Upper Hutt City Council  
Hearing - Wednesday 26 April 2023  
Intensification Planning Instrument

Stephen Pattinson

Submitter 65

Part 1 "Qualifying Matter Areas"

## 1976 flood - eye-witness 'ground-truthing' - continued

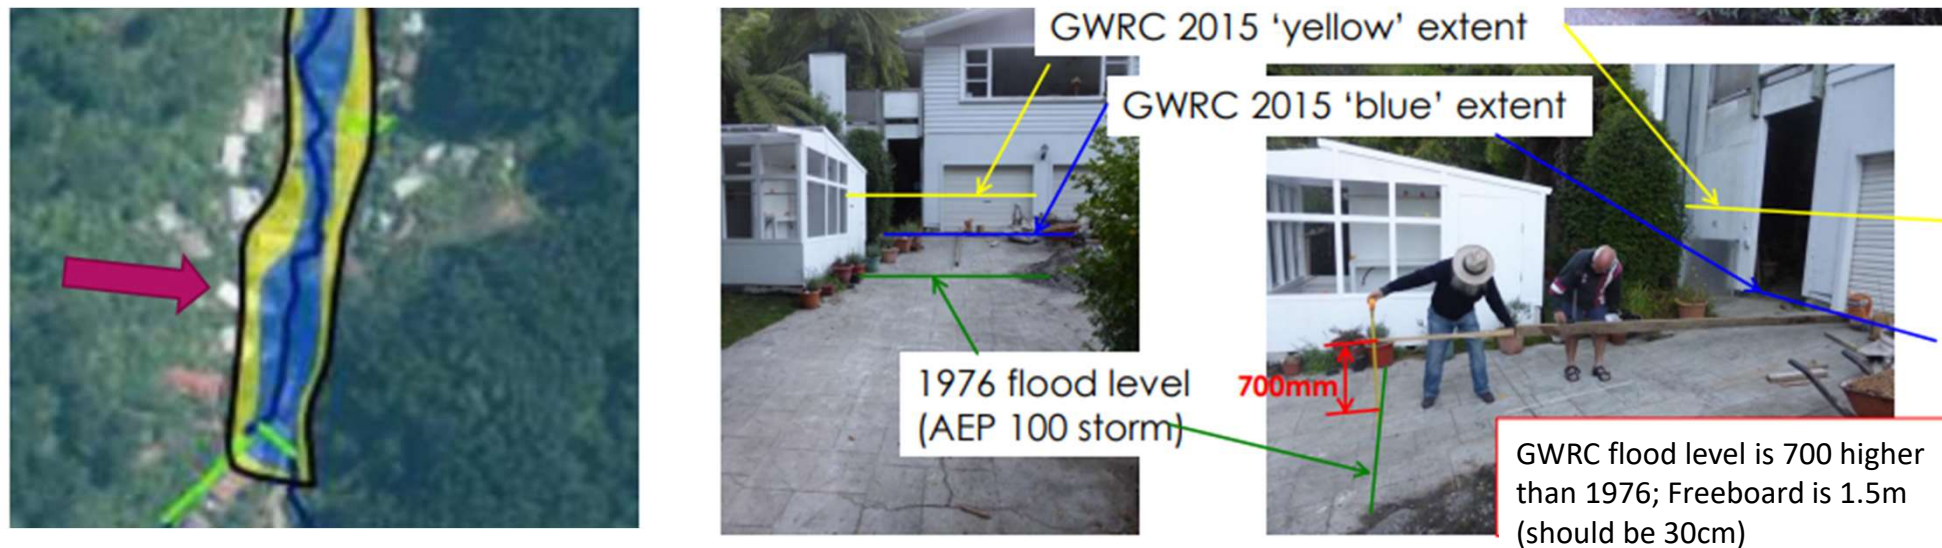
- GWRC Pinehaven flood map (2015)
- The 1976 flood came up the driveway at 138 Pinehaven Rd to the green line (see above) – (Kevin Keown, resident)
- GWRC's flood map predicts 100-year flood will rise 700mm higher (blue line) than the 1976 flood (green line)
- GWRC's freeboard is 1.5m (yellow line) above the predicted water level (blue line); it's supposed to be 30cm !

### Case Studies (Dec 2014)

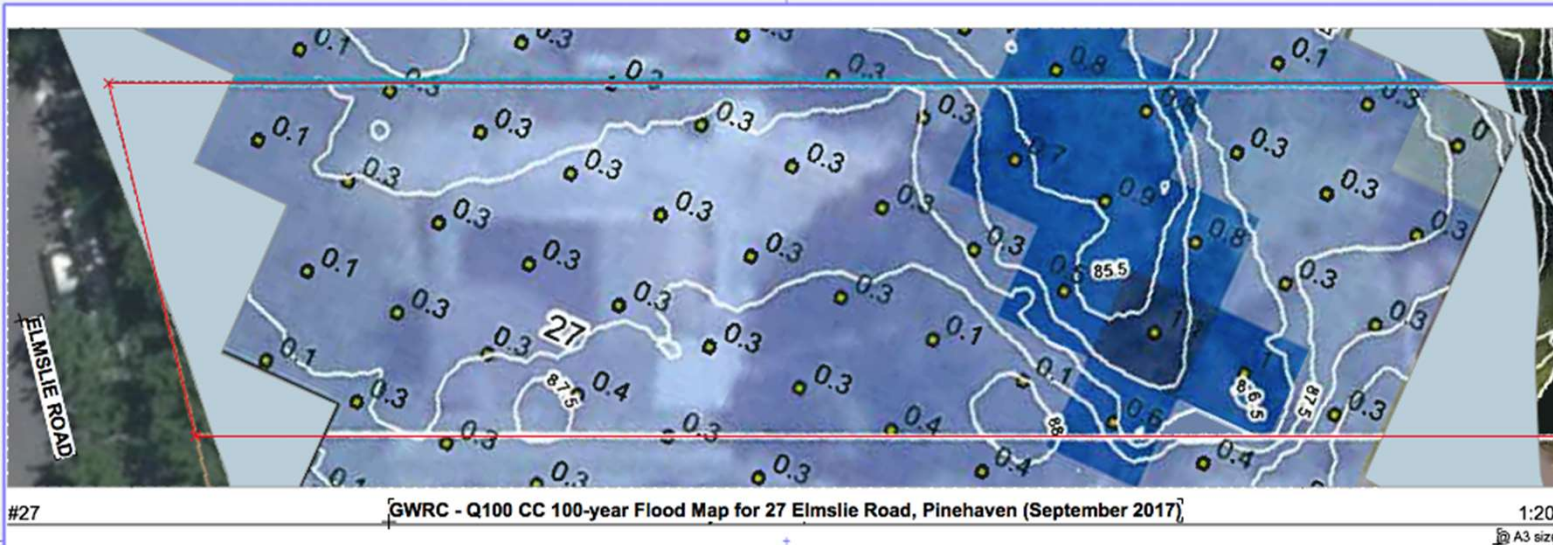
Case Study 1: 27 Elmslie Rd  
~ 15\*m<sup>3</sup>/s vs ~4.5\*m<sup>3</sup>/s

Case Study 2: Dunns Street  
~ 77\*m<sup>3</sup>/s vs ~25\*m<sup>3</sup>/s

Case Study 3: Pinehaven Reserve  
~ 50\*m<sup>3</sup>/s vs ~16\*m<sup>3</sup>/s

Top of  
Case Study 4: Pinehaven Road  
~ 19\*m<sup>3</sup>/s vs ~5\*m<sup>3</sup>/s

- Cross-sections were surveyed at each of these 4 locations (Co-Design Architects Ltd)
- GWRC's predicted 100-year flood levels were added to the cross-sections
- 30cm of freeboard was deducted from the water level in the cross-sections
- The cross-sectional area of water was multiplied by an assumed flow velocity of 1m/s to give an estimation of the volume of flow at each location
- **At all 4 locations the volume of flow is at least 3 times more than GWRC's published data for 100-yr flow at these locations**

GWRC 100-yr flood map, 27 Elmslie Road, Pinehaven:

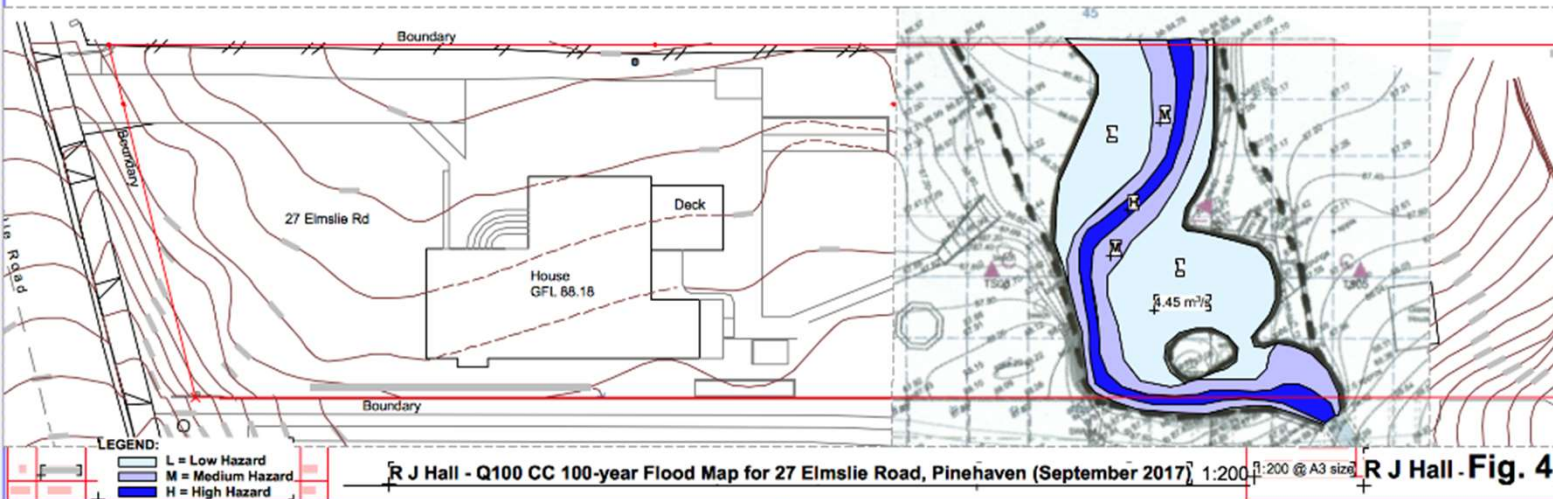
~ 15m<sup>3</sup>/s without freeboard

~ 33m<sup>3</sup>/s with freeboard, i.e. more than the peak flow for whole catchment in 1976 flood estimated at 30m<sup>3</sup>/s - see R.G. Bishop 1977 and G. Horrell, 10-8-2018)

RJ Hall & Assoc. 100-yr flood map - 27 Elmslie Rd. Calculated 100-year flow at 27 Elmslie Rd, 4.45m<sup>3</sup>/s (RJ Hall & Assoc.)

GWRC published data for 100-yr flow at 27 Elmslie Rd is similar, 4.8m<sup>3</sup>/s

## 5. Large errors in Council flood map for 27 Elmslie Road, Pinehaven

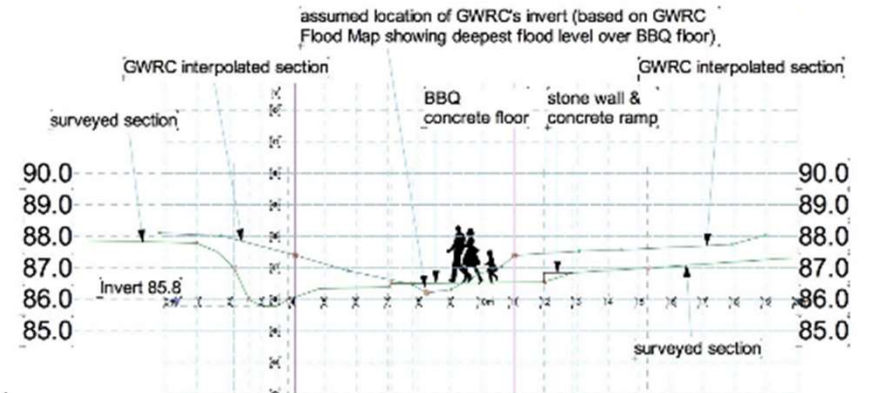
Horizontal error in location of stream = 8m  
Vertical error in ground height = 0.5m to 1.8m

### Channel Section Y-Y (based on Topo. Survey) compared with GWRC Interpolated Section at Chainage 640

### Channel Section M-M (based on Topo. Survey) compared with GWRC Interpolated Section at Chainage 650

Figure 5.2 Flood extent elements

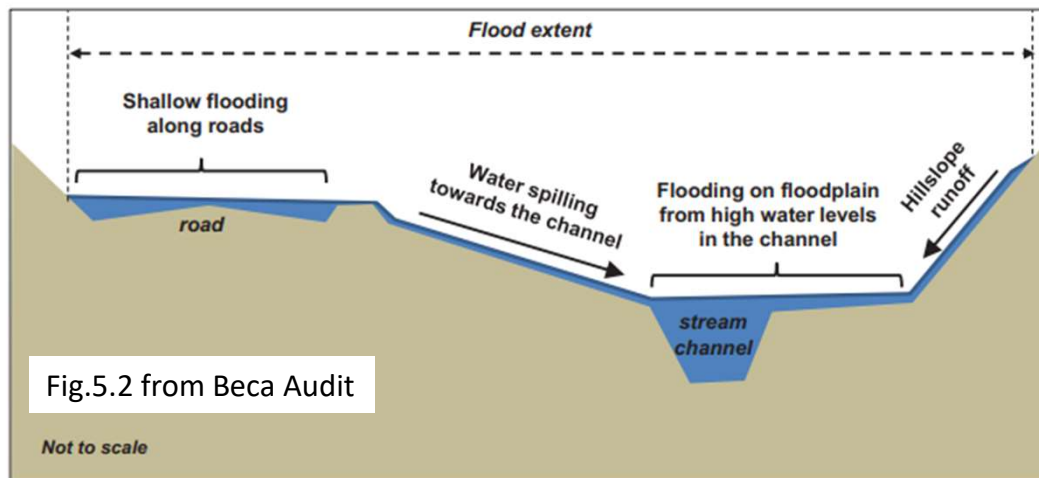
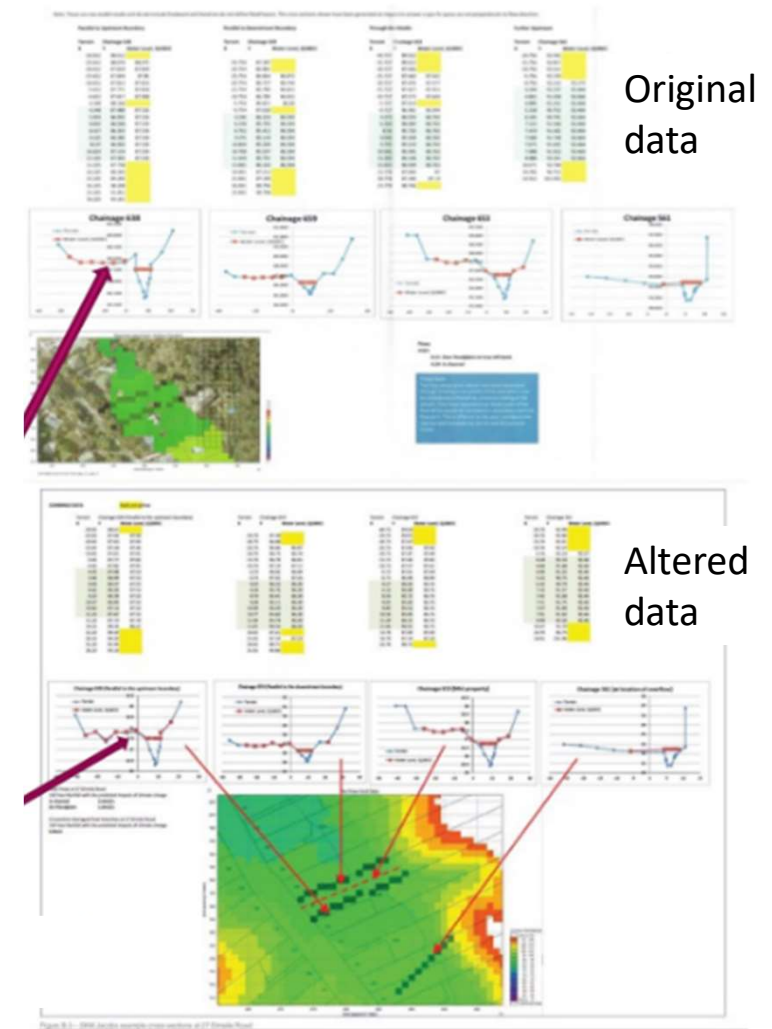
- Auditor's diagram (below) dismisses Case Studies 1 – 4, yet it is clearly not applicable to Case Study 2 (Dunns St)
- Nor is it applicable to Case Study 1 (27 Elmslie Road) but original data for 27 Elmslie Road has been altered to suit Auditor's diagram below to dismiss Case Study 1
- Diagram below confuses flood level with overland flow – a serious mistake (see next slide regarding Case Study 4)

## Case Study 4 – Top of Pinehaven Road: The danger of representing overland flow as flood level

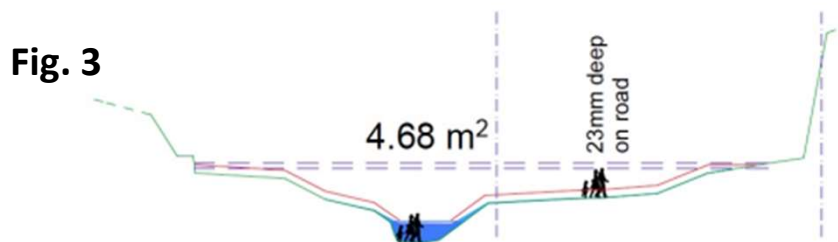
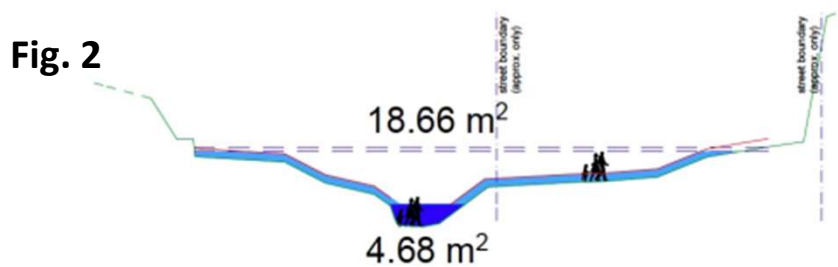
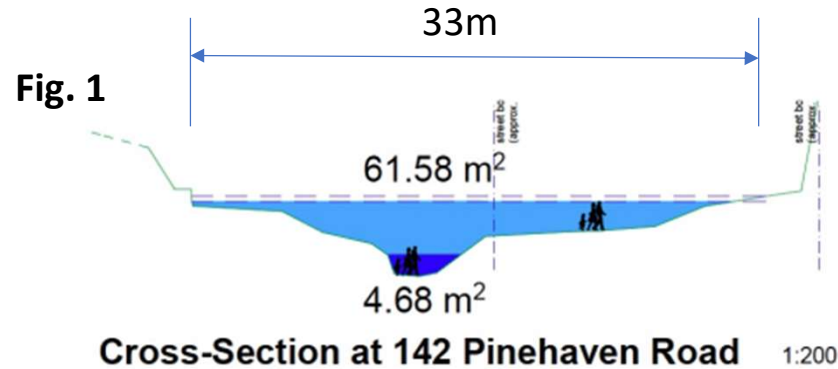
But what is really happening is that by combining overland flow (Fig. 2) with  $4.68\text{m}^3/\text{s}$  flood flow (Fig. 3) in their flood map (far right), the massive extra runoff from large-scale future development is masked.

2. Overland Flow - the Legend in SKM’s Vol. 2 (2010) flood maps describe light blue shading (in flood map far right) as “0 – 500mm”. This must be overland flow. According to SKM, it could be up to 500mm deep, creating a 33m wide floor extent (far right) of about  $19\text{m}^3/\text{s}$ , about 4 times more than there should be (and this is without including 30cm of freeboard)!

3. As in Figs. 1 & 2, 300mm (30cm) of freeboard has been removed in Fig. 3 to show the extent of 100-year flood flow at this location in the catchment calculated by SKM to be  $4.68\text{m}^3/\text{s}$ . Fig. 1 shows the extent of  $4.68\text{m}^3/\text{s}$  of flow as described to the writer by the GWRC Pinehaven flood Project Manager, viz. that there is 23mm of water on the road (cul-de-sac) feathering out to 0mm on the far (right) side of the road, and 40mm depth at the edge of the channel and the rest of the flood water in the channel.

Assuming a flow velocity of 1m/s, GWRC's flood map at 142 Pinehaven Rd is showing about **~19 m<sup>3</sup>/s** (after deducting freeboard), which is 3 times GWRC's calculated flow of approximately 4.7 m<sup>3</sup>/s.

## 7. Pinehaven 1-in-25 year flood 8 December 2019

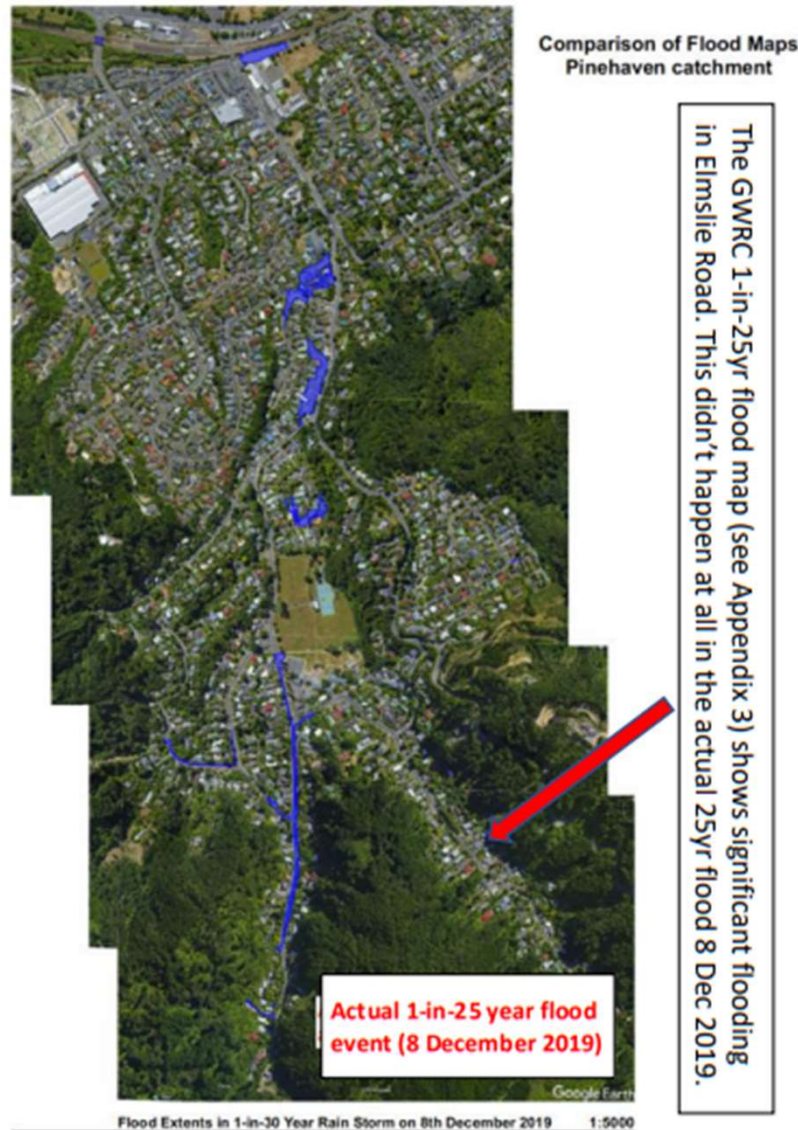
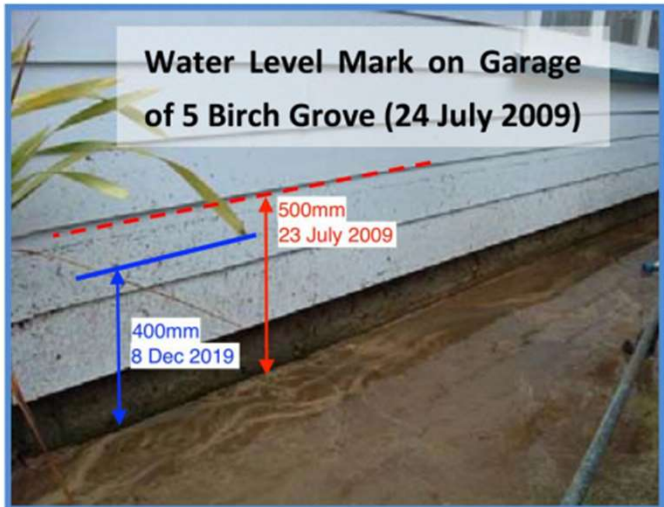
GWRC's 25-year flood map (above) looks nothing like actual 1-in-25 year flooding on 8 Dec 2019 (right)

Even GWRC's 10-year flood map (far right) far exceeds actual flood extents observed on 8 Dec 2019

The GWRC 1-in-25yr flood map (see Appendix 3) shows significant flooding in Elmslie Road. This didn't happen at all in the actual 25yr flood 8 Dec 2019.

### PINEHAVEN ROAD CULVERT

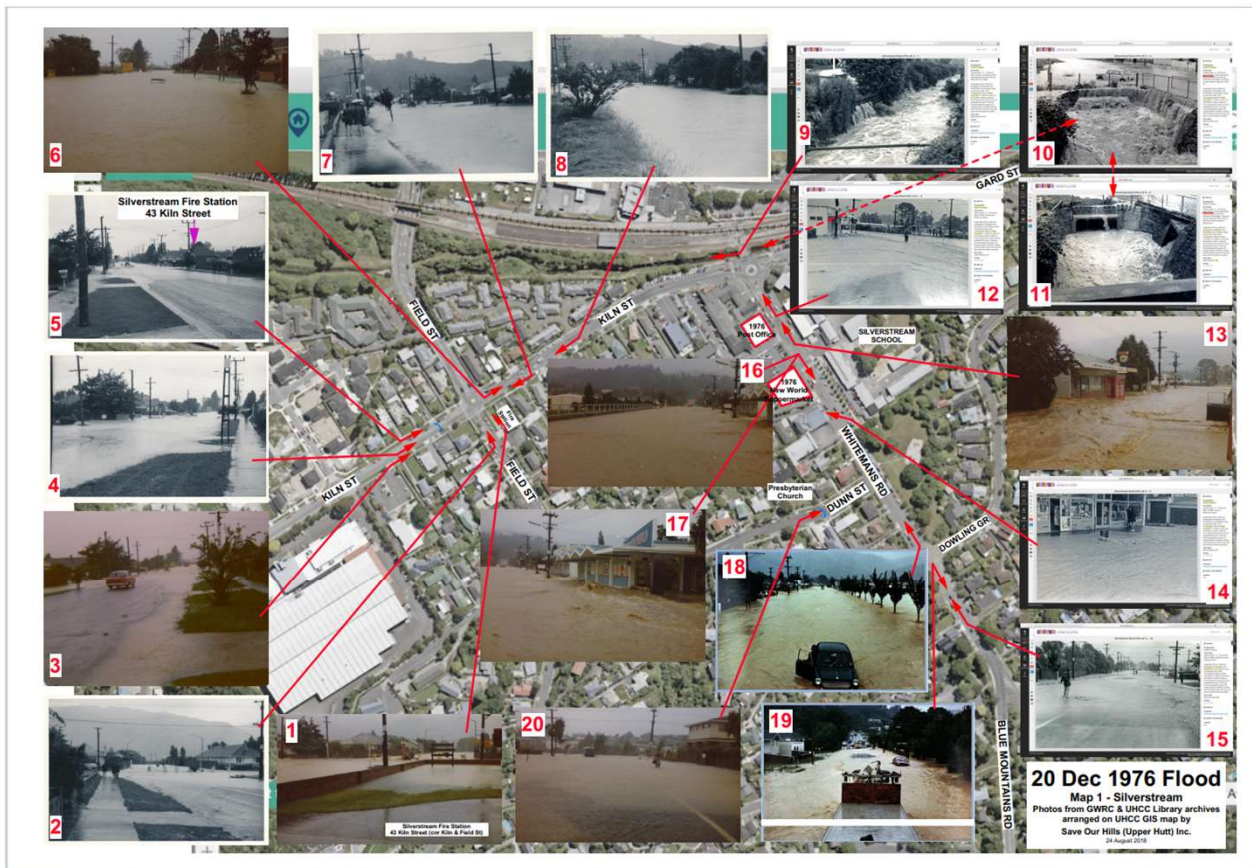
The Pinehaven Road culvert did not overtop during peak flow in this 1-in-25 yr flood event

8 December 2019 6:36am Screenshot from movie (44 seconds) of 1-in-25yr flood at peak flow at upstream intake of the Pinehaven Road culvert at the intersection of Pinehaven and Blue Mountains Roads. The movie and this screenshot from it show that the Pinehaven Road culvert coped perfectly well with the 1-in-25yr peak flow without overtopping.

Urgently **update** the flood model and maps for 27 Elmslie Road with better model inputs ...

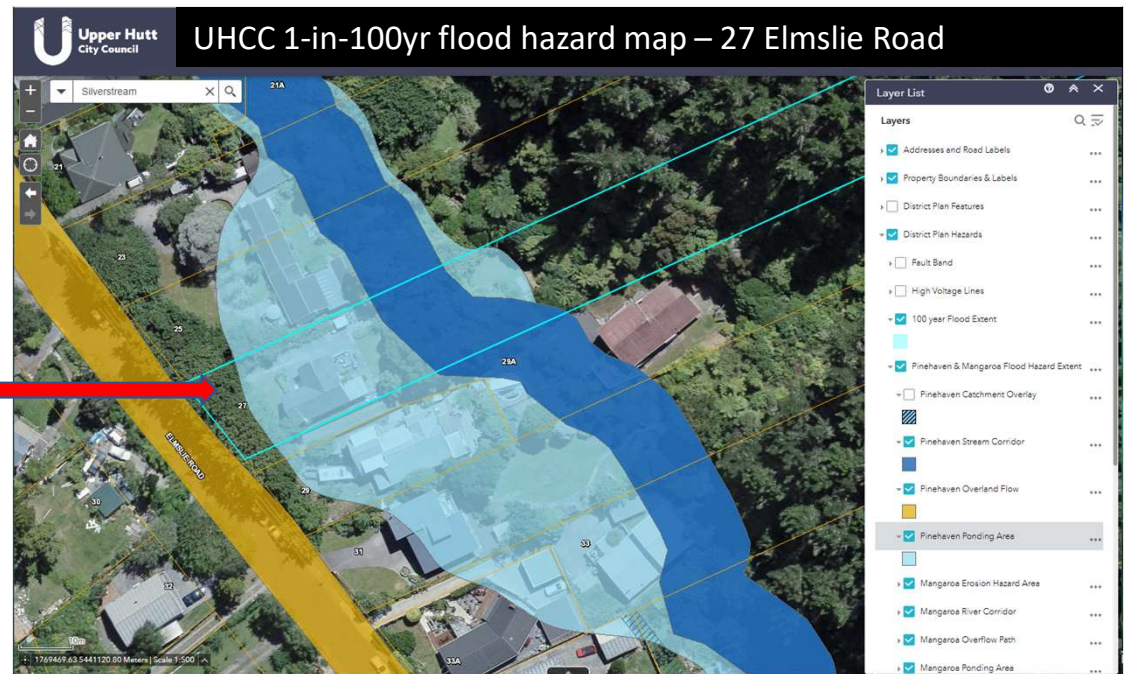
- GWRC's Pinehaven base flood model is now 15 years old
- The flood modelling is out of date regarding more recent rainfall and flood information
- The modelling uses a very crude 5m x 5m LiDAR grid resulting in large topographical errors
- Channel cross-sections are inaccurate, being interpolated between channel surveys up to 150m apart
- Very crude Manning's 'n' coefficient assumes upper catchment stream channels are totally filled in
- No account of the effect of buildings or fences on flood flow other than very crude floodplain coefficient
- GWRC removed the Pinehaven raingauge from the catchment while doing the flood model study
- Unthinkably, GWRC removed the stream gauge recorder causing the loss of 10 years of stream flow data

- Reject the current unreliable flood hazard maps as a 'qualifying matter area' for 27 Elmslie Road specifically;
- Ditto for Pinehaven and Silverstream generally;
- Re-assess the flood hazard zones for Pinehaven Stream using accurate input parameters that are truly representative of the catchment to provide:
  - a reliable base model for assessing hydraulic neutrality of future development
  - accurate and reliable flood hazard areas
  - accurate and reliable 'qualifying matter areas'
